Technical design note

Project name	Symmetry Park, Bicester Phase 3		
Design note title	Drainage Technical Note		
Document reference	22281-HYD-XX-XX-TN-C-0003		
Author	AB		
Revision	02		
Date	29 January 2025	Approved	✓

Technical note is to address objection received from Oxfordshire County Council Lead Local Flood Authority (OCC LLFA) dated 02.01.2025 in relation to application no. 24/03259/F for Land Adjacent to Symmetry Park, Morrell Way, Bicester, OX26 6GF.

TITLE		
CATCHMENT PLAN		
HYDROCK PROJECT NO. 22281	SCALE @ A1 1:1000	
STATUS DESCRIPTION SUITABLE FOR REVIEW & COMMENT		STATUS S3
DRAWING NO. 22281-HYD-XX-XX-DR-C-0530		REVISION P02

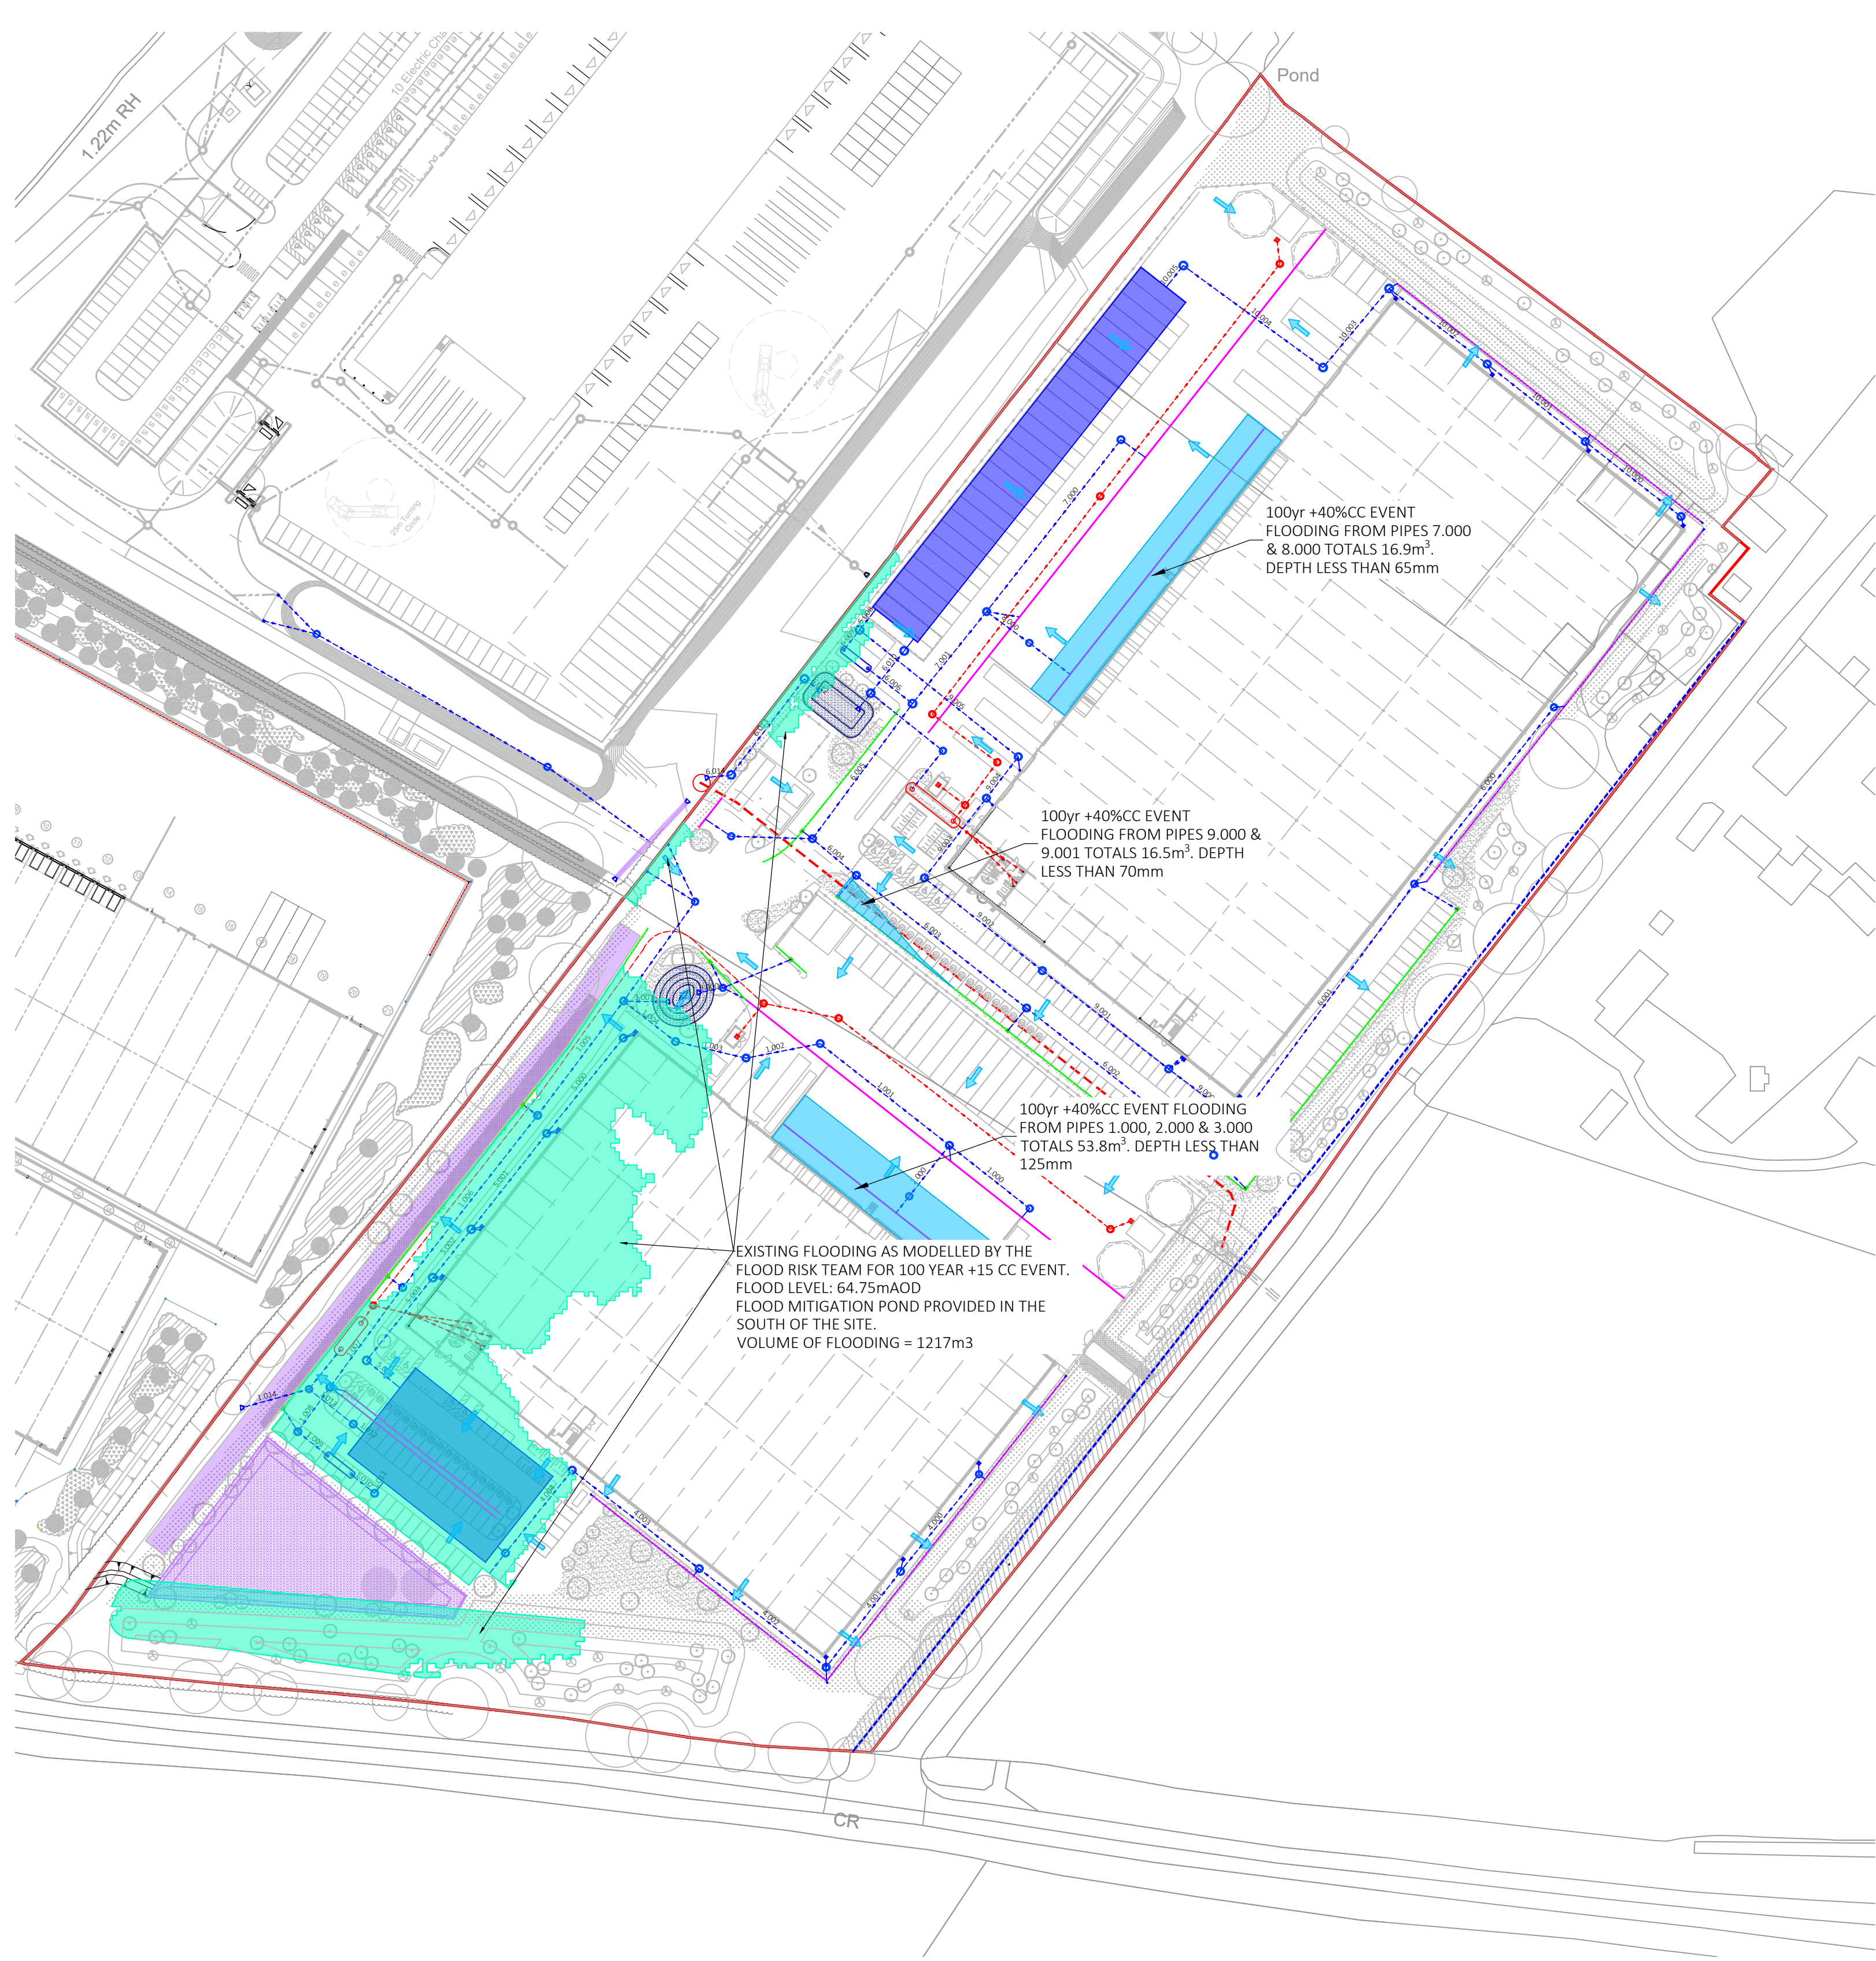
1. Provide surface water catchment plan.

Provide surface water catchment plan, clearly showing the extent of the impermeable area and stating the area. Each catchment should show where it will be draining.

Hydrock Response: Please refer to the Catchment plan, drawing number 22281-HYD-XX-XX-DR-C-0530 in Appendix C of the Drainage Strategy Report submitted as part of the original submission. This drawing shows the full extent of impermeable catchment areas, the area of each is labelled (in ha) and the catchment naming corresponds to the pipe where each catchment is draining to. This also matches what has been modelled in Microdrainage (refer to Appendix D of the Drainage Strategy Report).

TITLE FLOOD EXCEEDANCE PLAN		
HYDROCK PROJECT NO. 22281	SCALE @ A1 1:1000	
STATUS DESCRIPTION SUITABLE FOR REVIEW & COMMENT		STATUS S3
DRAWING NO. 22281-HYD-XX-XX-DR-C-0540		REVISION P02

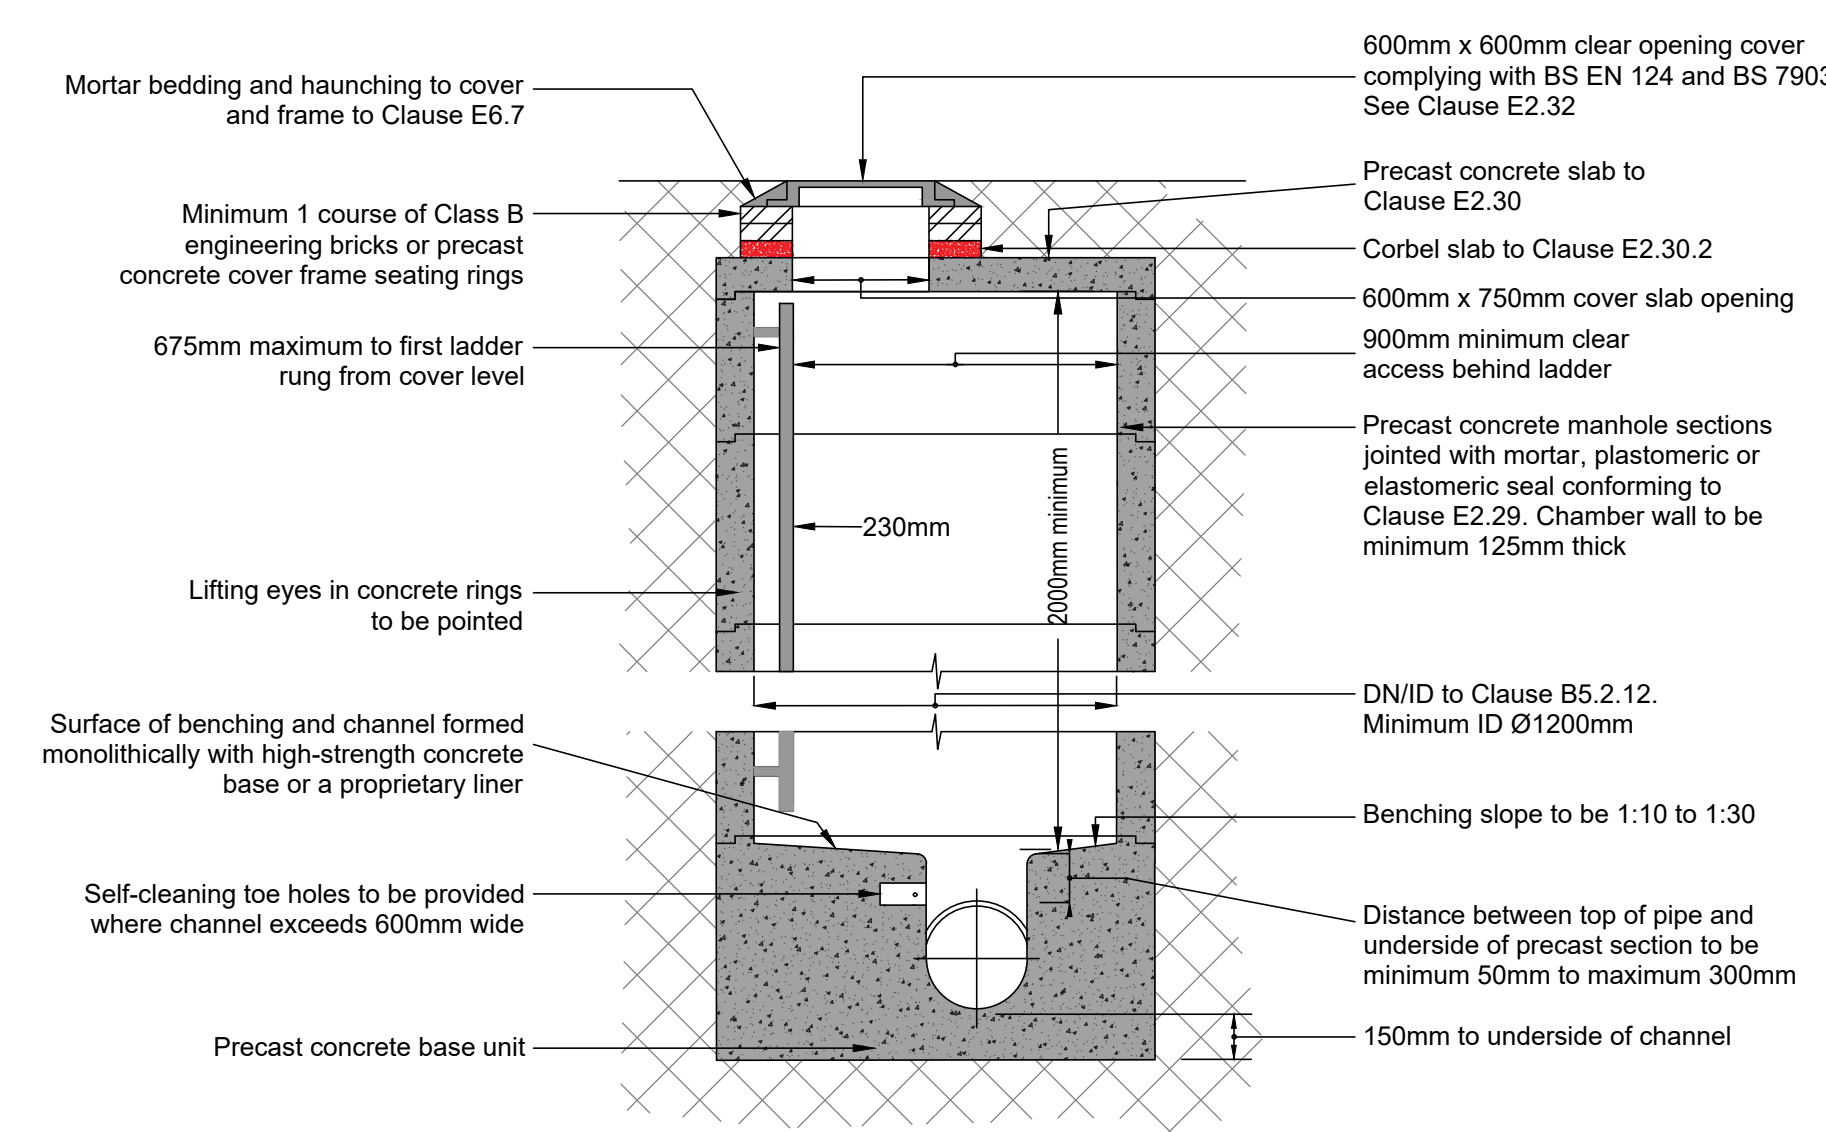
5. Provide surface water flood exceedance plan.

Provide flood exceedance plan, showing how surface water will be draining with the use of flood arrows.

Hydrock Response: Please refer to the Flood Exceedance Plan, drawing 22281-HYD-XX-XX-DR-C-0540 in Appendix C within the Drainage Strategy Report submitted as part of the original submission. This plan shows the surface water flood extents in the 100yr +40% CC event, the location, extents and depth as per the modelled results from Microdrainage. These flood waters are safely contained onsite until they can re-enter the system once the storm subsides. The Flood exceedance plan also shows overland flow routes, illustrating how surface water will be draining across the site.
